RE: ITB 25T-DV-119 Baxter Family Housing - Vertical Construction

ITB 25T-DV-119 Baxter Family Housing - Vertical Construction Addendum No. 1

PROJECT: Baxter Family Housing - Vertical Construction

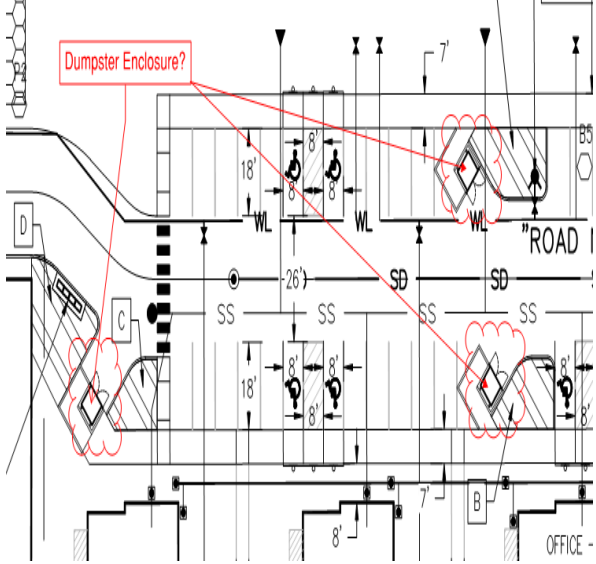
10. Detail 1/A6.2 shows typical wall sections. The detail labeled "Foundation if soil condition require drain at crawl space" suggests that it up to the bidder to determine if foundation drain is required even though Drawing A2.1 indicates foundation drain around the entire exterior of the building. In order to correctly and effectively evaluate bids,	<i>Civil recommends foundation drains due to the presence of groundwater during an unseasonably dry fall and winter. A footing drain service is provided for the building foundation drains. Again, the foundation drains will need to be</i>

<p>please define clearly that the foundation drain is or is not to be included in the bidders scope.</p>	<p><i>pumped up to the footing drain elevation to operate properly.</i></p>
<p>11.Detail 1/A6.2 shows typical wall sections. The design is showing the vapor barrier (VB) extending up the walls and through and between the floor framing member. While this detail can be achieved on exterior walls that run parallel to the floor framing it is very difficult to get a good seal around I-Joist. In lieu of VB at the I-Joist we recommend applying closed cell spray urethane foam that create an effective seal between the VB and the floor sheathing above. At the crawl space where a GWB thermal barrier does not cover the urethane foam per IBC & IRC requirements we can apply 3M Fire Dam Spray 200 over the urethane spray form in lieu of GWB. This method will help meet the BEES blower door test and thermal requirements.</p>	<p>This is acceptable</p>

<p>12. The 1/A6.2 wall details appear to indicate thermal bridging pathways as indicated below. Should the detail be changed to provide an equivalent insulation R-Value of the wall batts in rigid insulation exterior of the building to avoid thermal bridging?</p>	<p><i>The detail shown below is an acceptable solution</i></p>
